Variation to DA 020/0003/14A

203 North Terrace, Adelaide

Development Authorisation 020/0003/14A Variation 1 - Internal works and changes to the southern façade affecting a State Heritage item

A1		DRAWING NUMBER		Job Number		Sheet No.		Rev.	
Design	SI	Drawn	MJS	WAD121048	S1.20	C

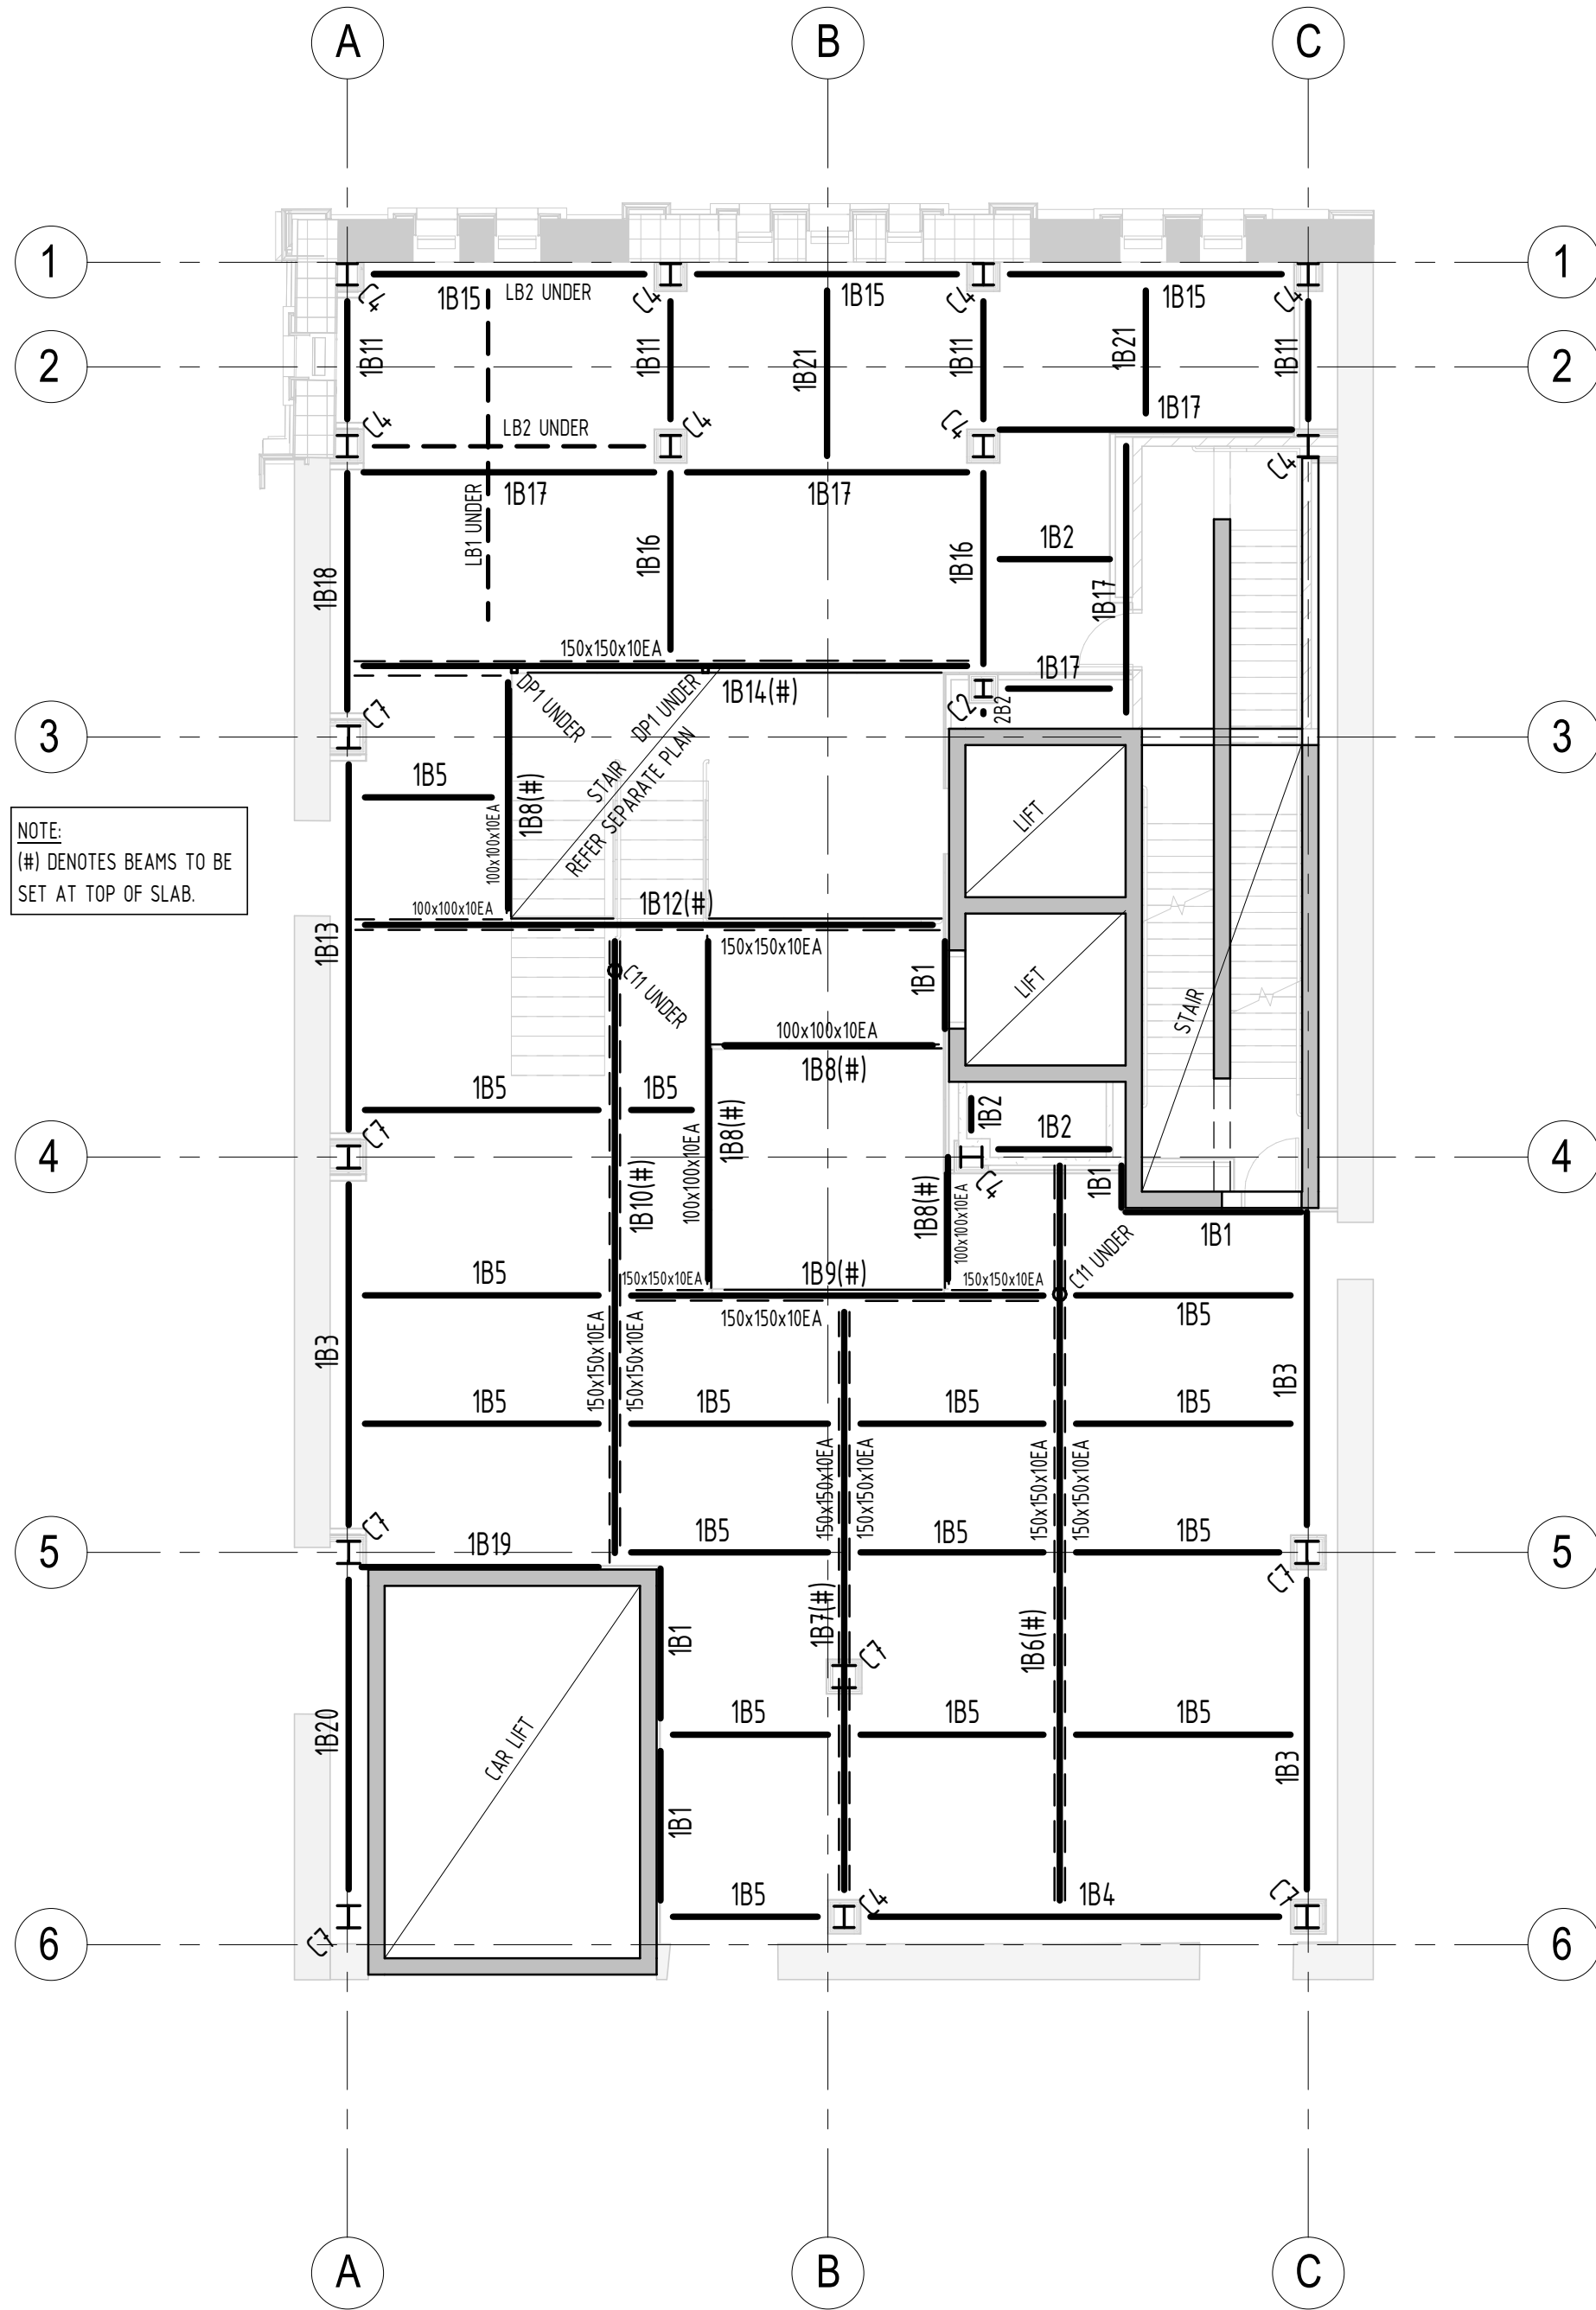
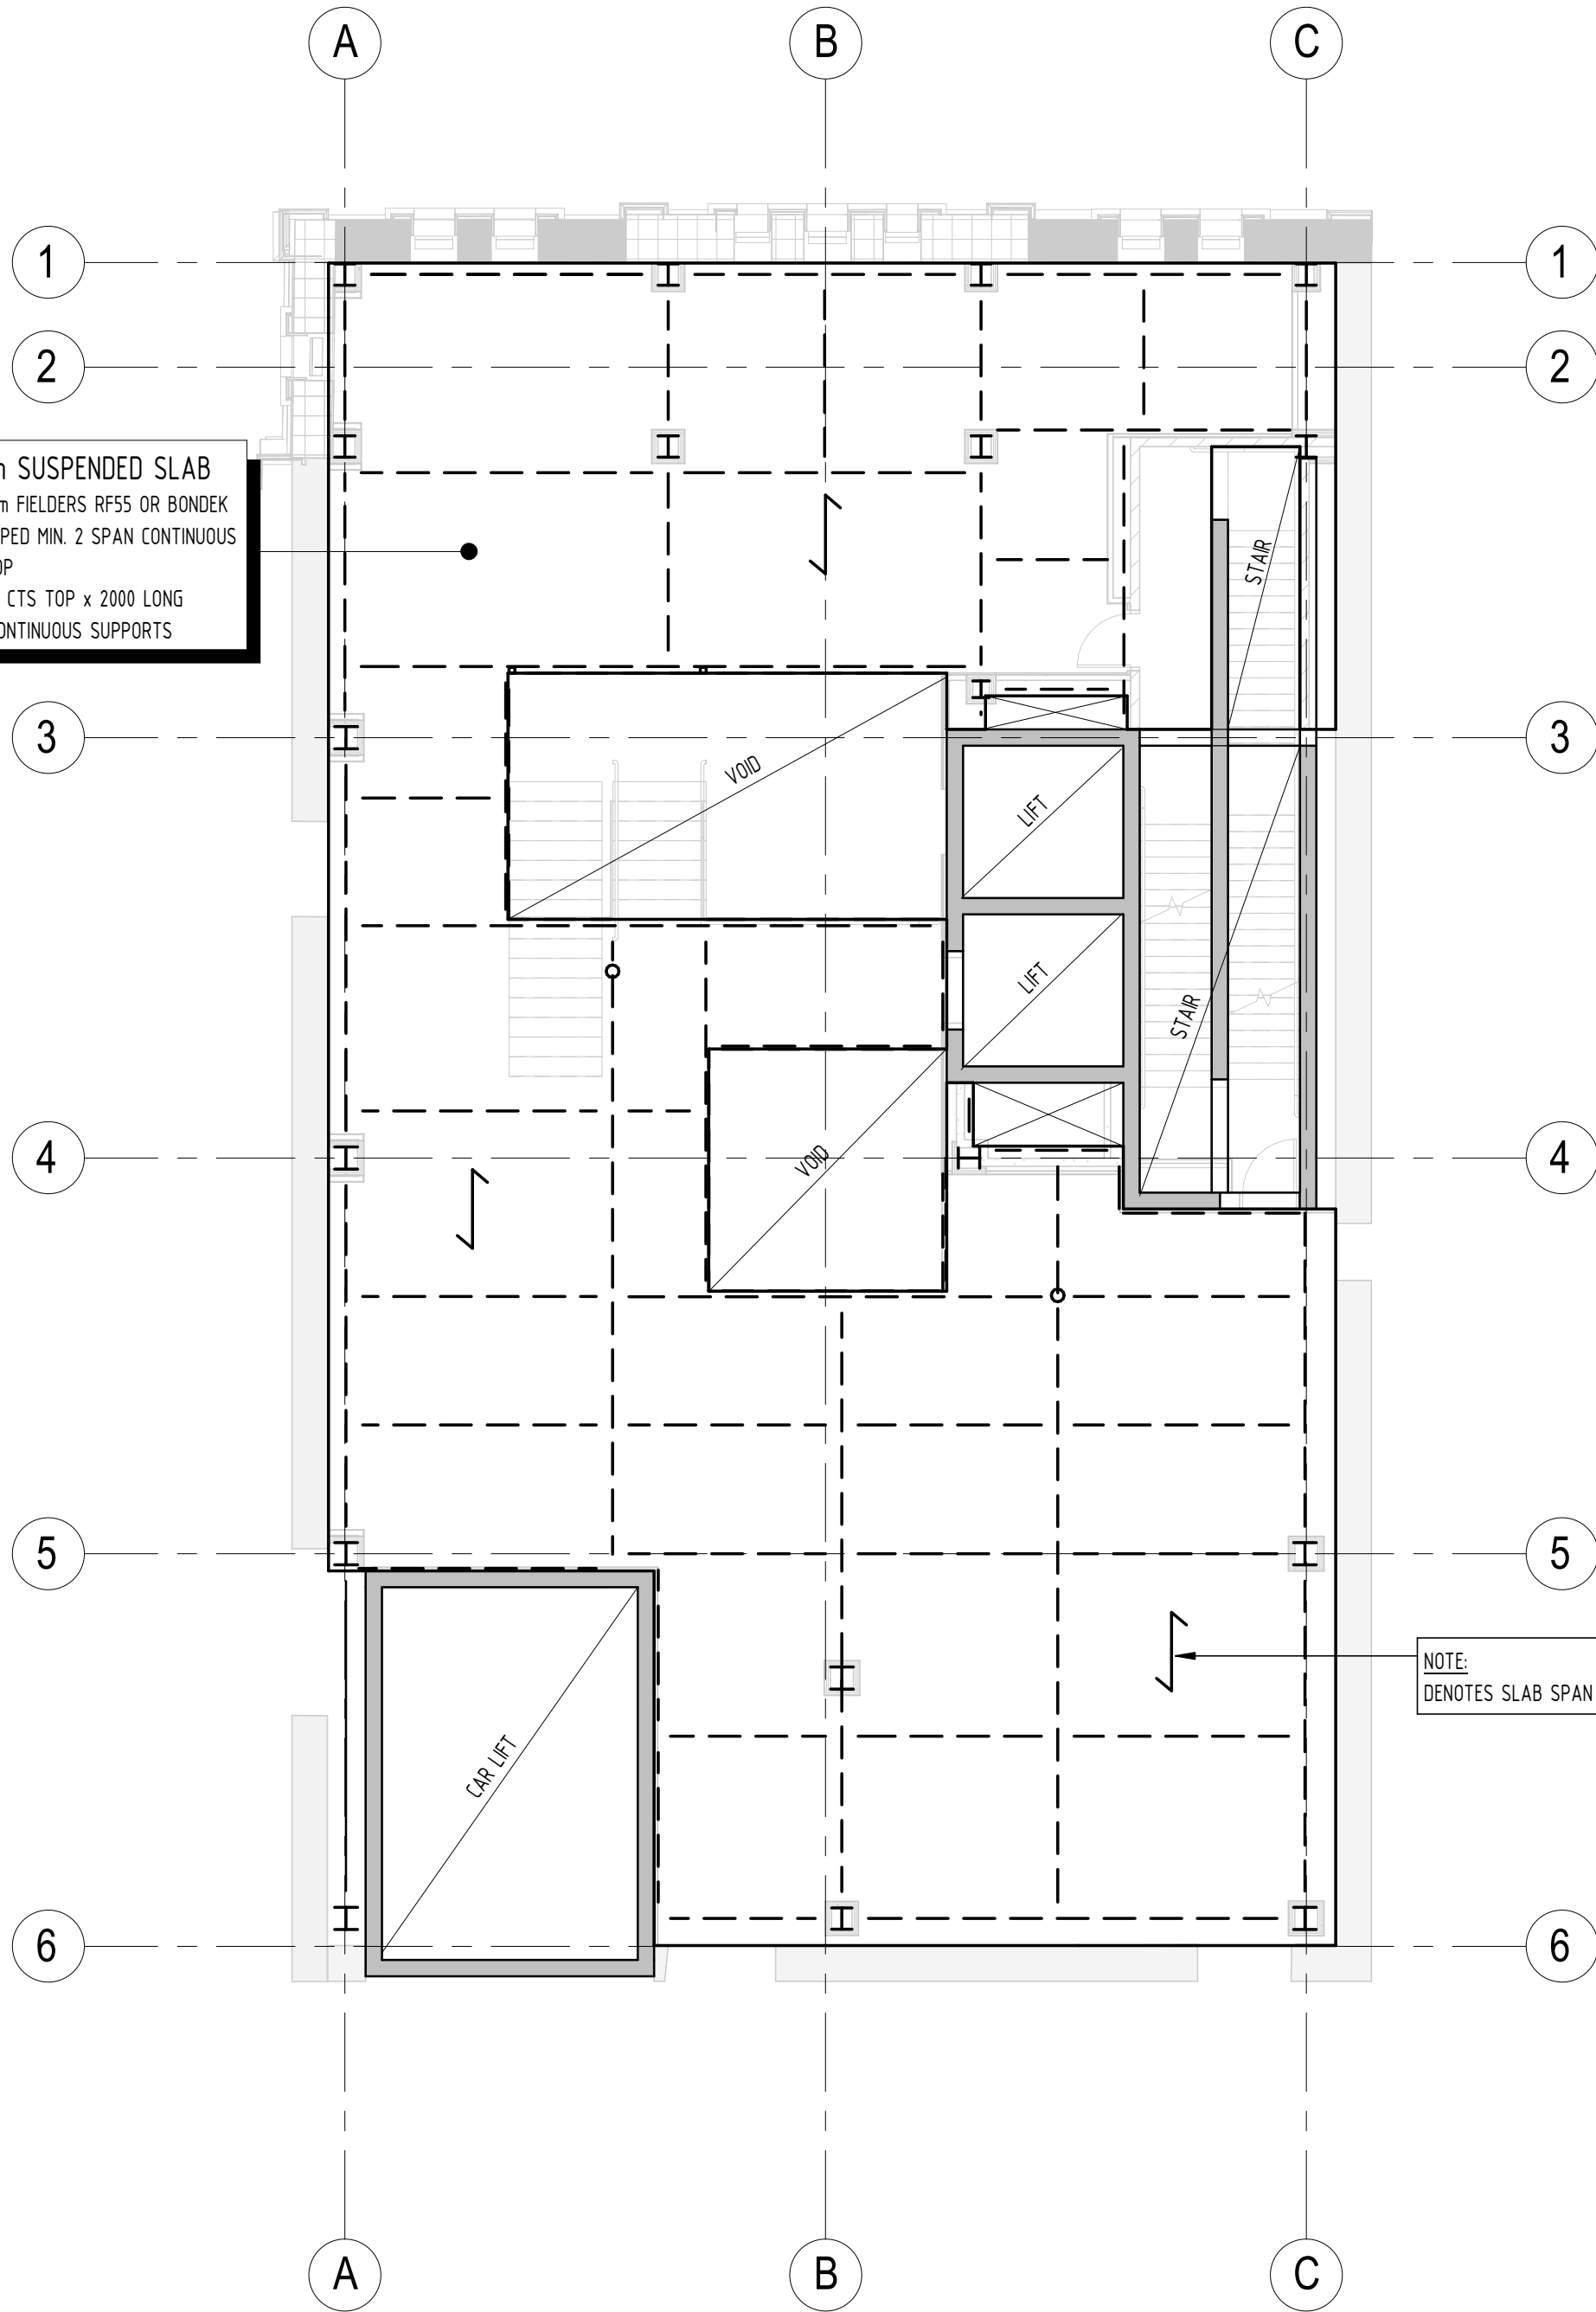
A report by Adelaide Pest Control identified that a long-term commercial warranty from a certified termite eradication contractor cannot be provided. It is therefore proposed that a new structural steel and concrete slab solution for both Level 1 and the southern portion of Ground Level be employed. The revised structural

- The new Level 1 steel support structure is arranged in such a way to simulate the old bearer locations, height and proportions. The concrete slab spans between these main members (refer structural layout WAD121048 S1.20). The timber matchboard lining is applied under a line of fire rated plasterboard, a building rules requirement to protect the base structure. The plasterboard is exposed to express the shape of the bearers (ceiling plan 33-17640 A-0201, detailed 33-17640 A-0656)

CAR LIFT REAR (SOUTH) WALL SECTION

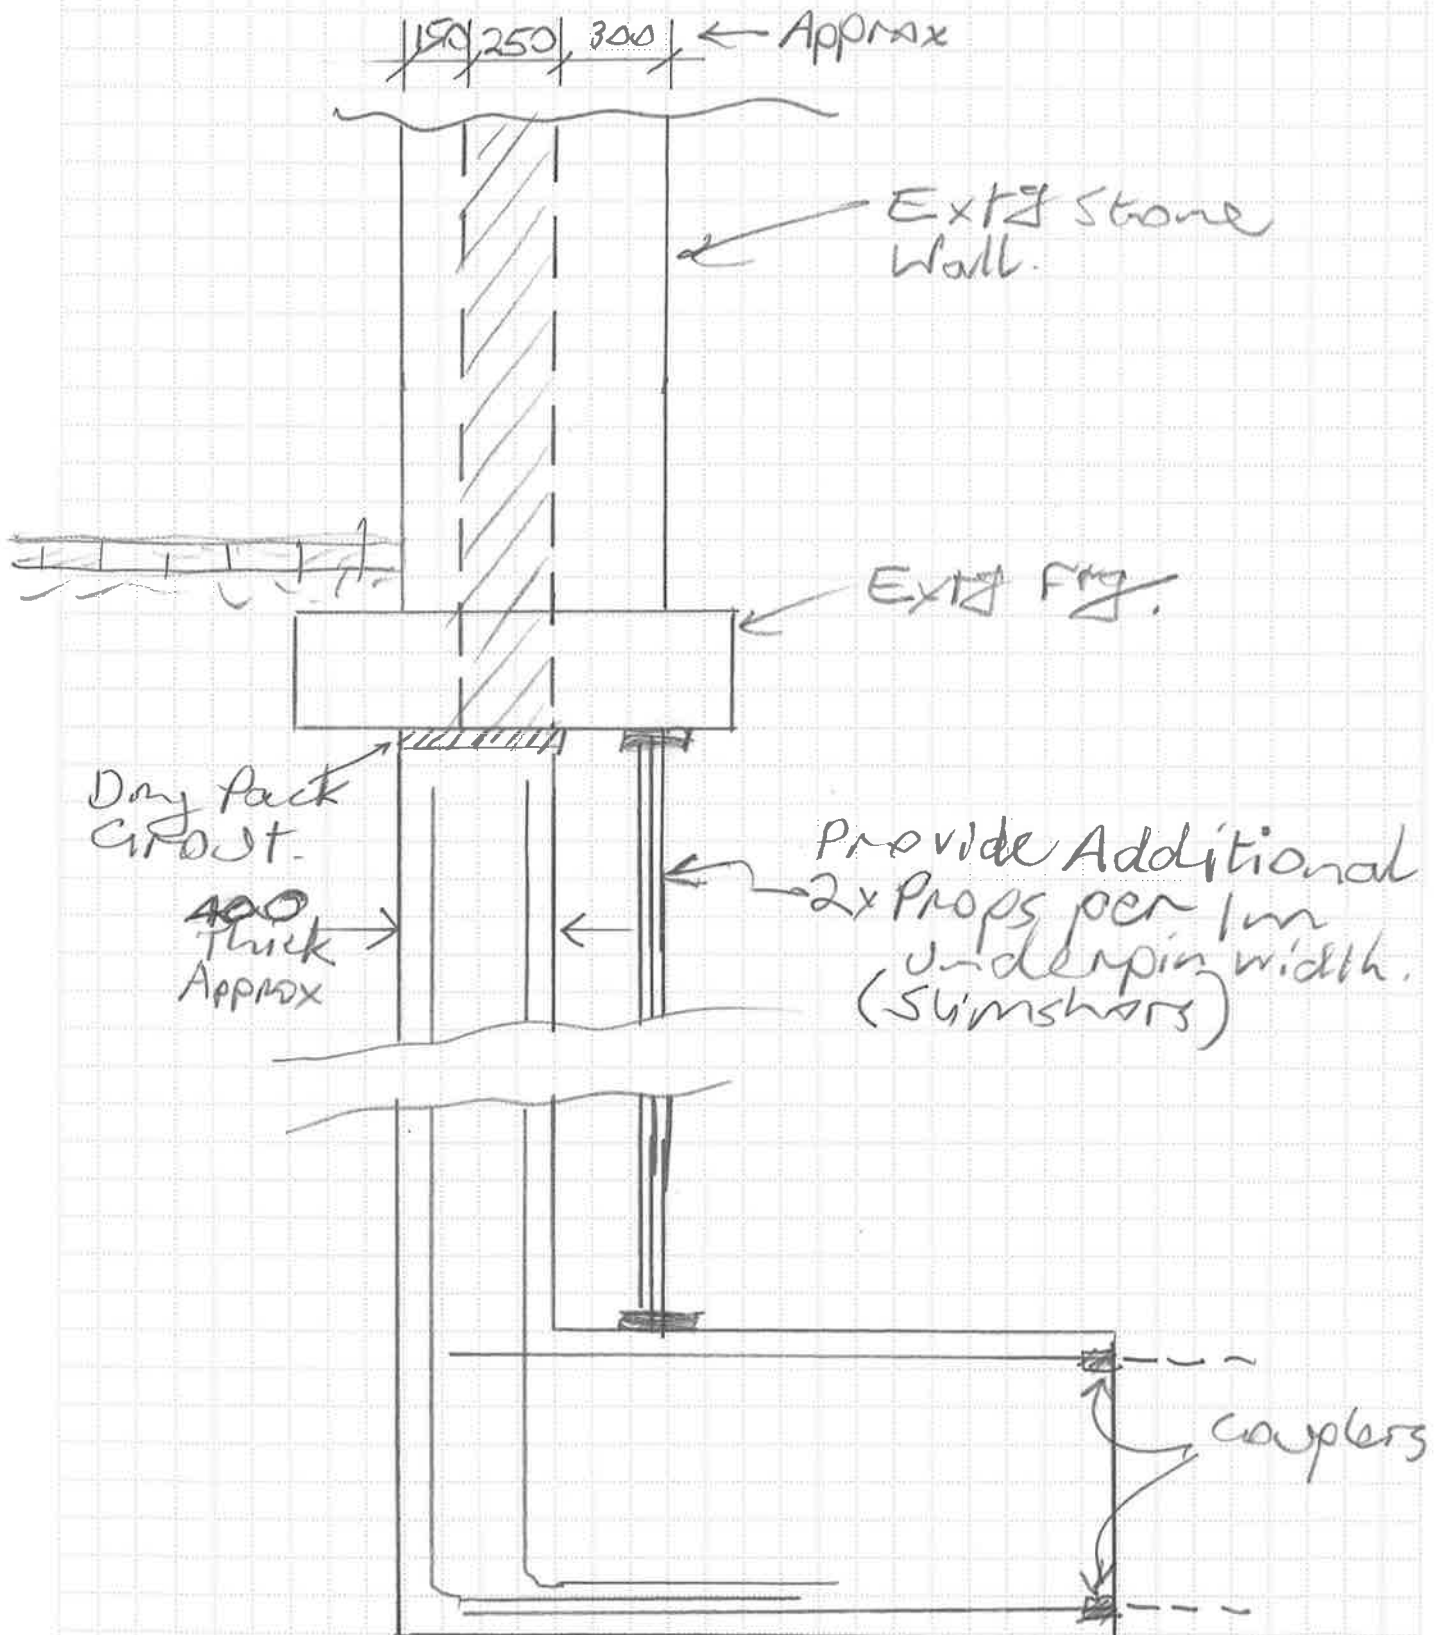
- Variation to the preceding point is the rear (southern) wall of the car lift shaft (refer sketch SK137). Due to the geometry the underpin will be offset to the stone wall above. Proceed in a similar fashion and in addition provide 2 Slimshor props per 1m underpin segments, installed prior to commencing the next stage underpin segment.
